Project	IEEE 802.16 Broadband Wireless Access Working Group http://ieee802.org/16 >		
Title	Suggested Modifications to AK Caching Solution		
Date Submitted	Initial: September 12, 2006 Revision r1: October 30, 2006		
Sources	Simon Mizikovsky, Robert Rance, Dan Gal, Peretz Feder Lucent Technologies	Voice: +1 973 386 6348 [mailto:smizikovsky@lucent.com]	
	Phillip Barber Huawei, Inc.	Voice: +1 972 365 6314 [mailto: pbarber@huawei.com]	
	Joe Schumacher Motorola	Voice: +1 847 632 5978 [mailto:j.schumacher@motorola.com]	
	Steve Upp Motorola	Voice: +1 847 576 4953 [mailto:Steve.Upp@motorola.com]	
	Walter Goulet Motorola	Voice: +1 847 576 7036 [mailto:Walter.Goulet@motorola.com]	
Re:	IEEE 802.16 Cor2 Change Request (CR) number 417 (Ballot #23, October 2006)		
Abstract	Proposed changes to the 802.16e-2005 standard to correct AK Caching Solution issues.		
Purpose	Incorporation in 802.16Cor2 draft		
Notice	This document has been prepared to assist IEEE 802.16. It is offered as a basis for discussion and is not binding on the contributing individual(s) or organization(s). The material in this document is subject to change in form and content after further study. The contributor(s) reserve(s) th

Figure 1300—HMAC/CMAC/KEK derivation from AK

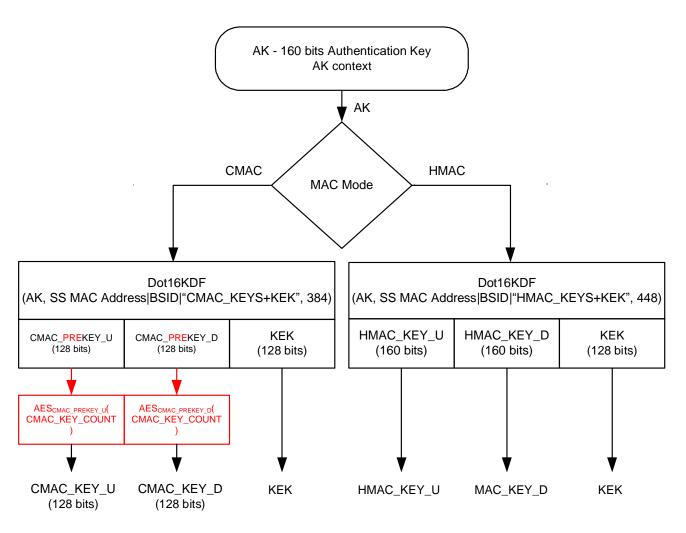
Change 6: Modify CMAC Key derivation figure.

[Please insert the red text and graphics as follows in Figure 1300, page 283 of 802.16e-2005]
